**PUD &  
SUBDIVISION STAFF REPORT****Date: September 2, 2004**

<b><u>DEVELOPMENT NAME</u></b>	Greenwood Subdivision
<b><u>SUBDIVISION NAME</u></b>	Greenwood Subdivision
<b><u>LOCATION</u></b>	251 South McGregor Avenue (West side of South McGregor Avenue, 200'± North of Pinebrook South)
<b><u>CITY COUNCIL DISTRICT</u></b>	District 5
<b><u>PRESENT ZONING</u></b>	R-1, Single-Family Residential
<b><u>AREA OF PROPERTY</u></b>	2.0± Acres                      5 Lots
<b><u>CONTEMPLATED USE</u></b>	Five Lot, Single-Family Residential Subdivision with a Gated Private Street
<b><u>TIME SCHEDULE</u></b>	Immediate
<b><u>ENGINEERING COMMENTS</u></b>	Discharge onto adjacent property cannot be increased or concentrated without a hold harmless agreement from the affected property owner. Must comply with all stormwater and flood control ordinances. Any work performed in the right of way will require a right of way permit.
<b><u>TRAFFIC ENGINEERING COMMENTS</u></b>	Driveway number, sizes, location and design to be approved by Traffic Engineering and conform to AASHTO standards.

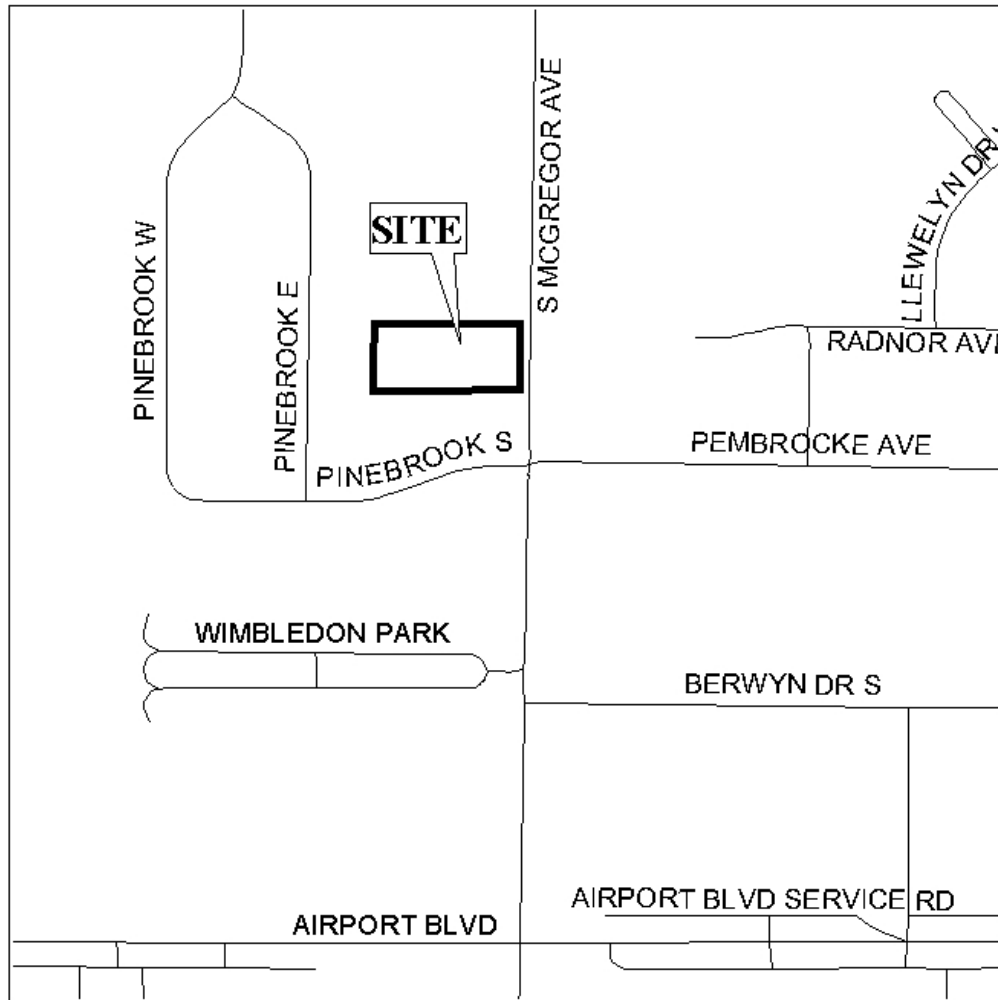
The plat indicates dedication of additional right-of-way to provide 40' from centerline, in conformance with the Major Street Plan. The plan also indicates only one point of access, the proposed private street, thereby providing adequate access management; providing that a condition is placed on any approvals denying Lot 1 direct access to McGregor Avenue.

There is an existing dwelling located on the site. This dwelling should be removed prior to recording of the final plat if the PUD and subdivision are approved.

The plat indicates the detention for the site is to be provided in the Southwest corner of the site. The Engineering Department will have final approval of the detention facilities.
